Representation of Flitwick Town Council to the proposed development at Land to the side and rear of 41 to 47 Coniston Road, Flitwick

Appeal reference: APP/P0240/W/22/3311532

Application reference: CB/22/01771/FULL

Submitted to the Planning Inspectorate on 2nd April 2023

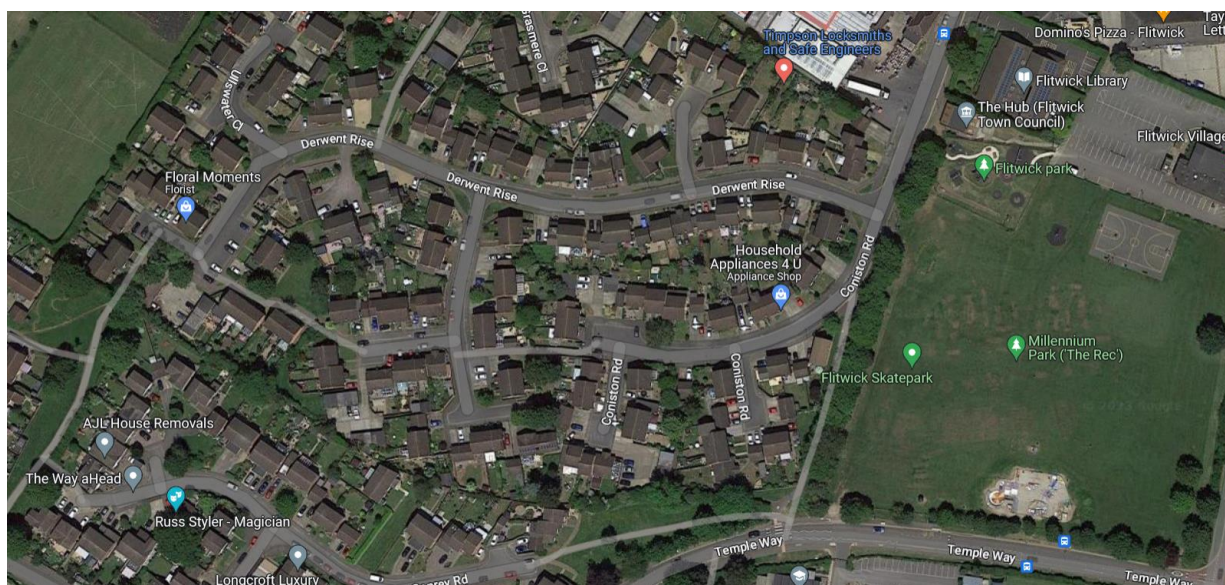
The Town Council notes that the point where the site is closest to the public highway on Coniston Road is 45 metres. Therefore, all parts of the ground floor being within 45 metres of the public highway is impossible.

When measured on a map, the access to the public highway on Temple Way is within 25 metres of the site. However, it must be noted that this is the site of a zebra crossing with bollards. Not only would this, plus a sharp left turn between trees and a fence as the vehicle approaches from Temple Way, make vehicle access from this side impractical, but this would mean that the emergency vehicle would need to park away from the zebra crossing so as not to cause an obstruction.
